**PLANNING DEPARTMENT
CURRENT PLANNING DIVISION
MAJOR SITE PLAN REVIEW**

CASE NO: 2018-0041

REQUEST: Major Site Plan Review of a Large Commercial Establishment for renovation of the former Sears store at the Sears Mall

RECOMMENDATION: Approval with conditions

1 COMMONS CEILING PLAN
1/8\"/>

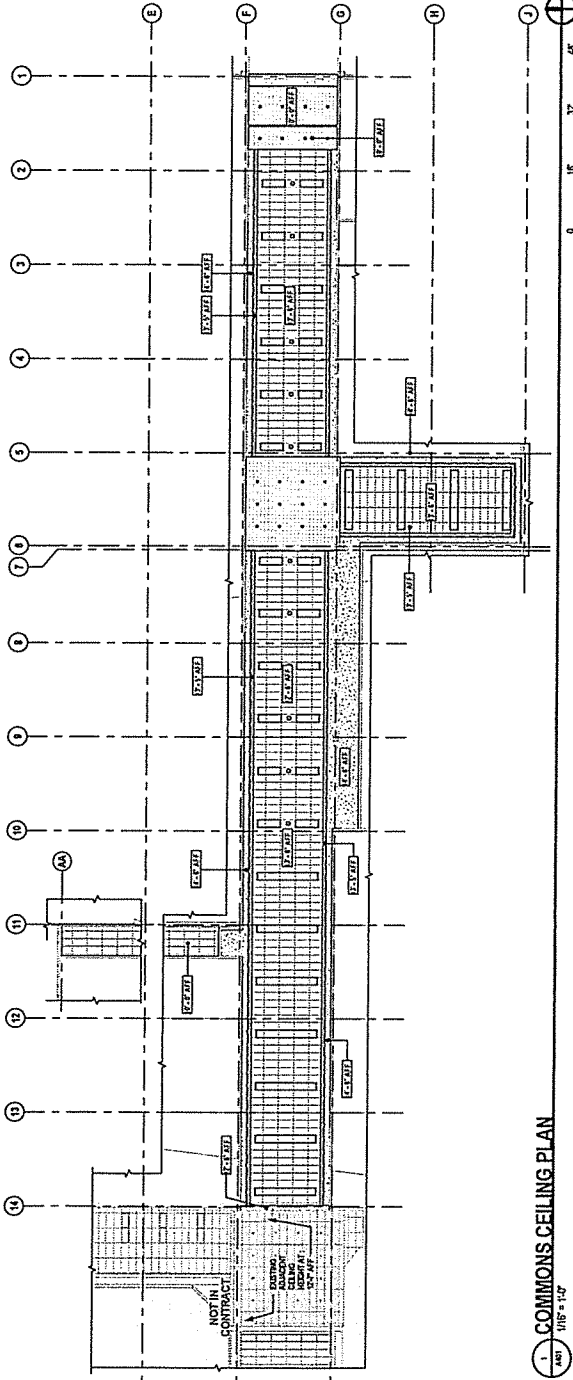
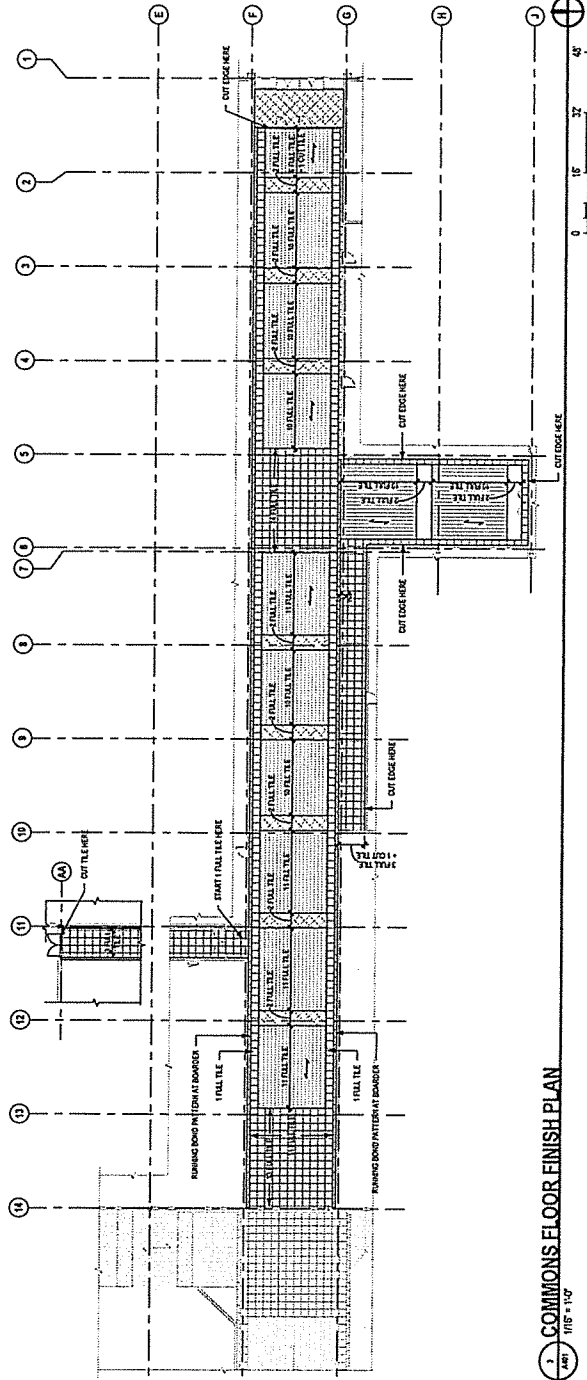
The proposed site plan includes an interior “mall commons” connected to the central common mall entrance on the east side of the building. The area is noted as 30.5 feet wide on plan sheet G002, and the scaled drawings on sheet A101 indicate the length is roughly 96 feet, creating an area that exceeds the minimum 2000 square foot requirement. The standards of 21.07.060F.11 do not appear to be fully met; however, this site has nonconforming rights for the lack of required community space. The addition of common space is a change in the direction of conformity.

EAST ELEVATION - NORTH PORTION

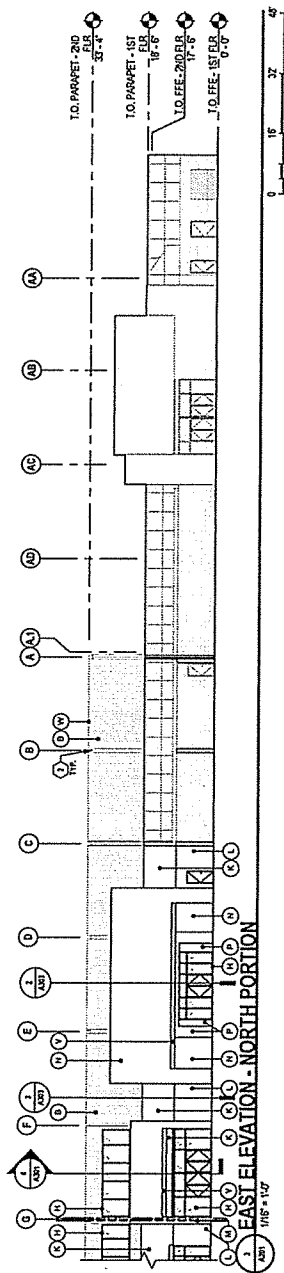
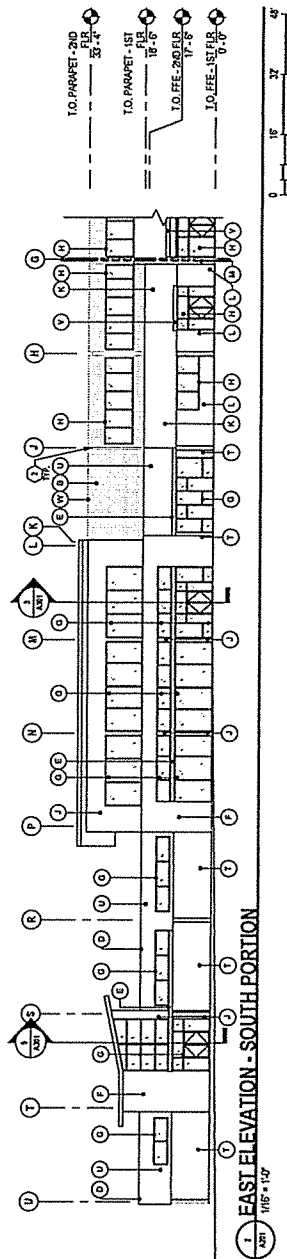
- iii. The elevation drawings show sidewalk overhangs. No dimension for the depth of the overhang was noted and no information was provided to verify the percentage of building frontage with overhangs. The addition of the sidewalk overhangs is a change in the direction of conformity.

The additions to the east elevation will create multiple roof modulations. The applicant did not provide calculations for the percentage of frontage, or dimensions for the length of the roof modulations, but the elevation drawings provided appear to meet this requirement.
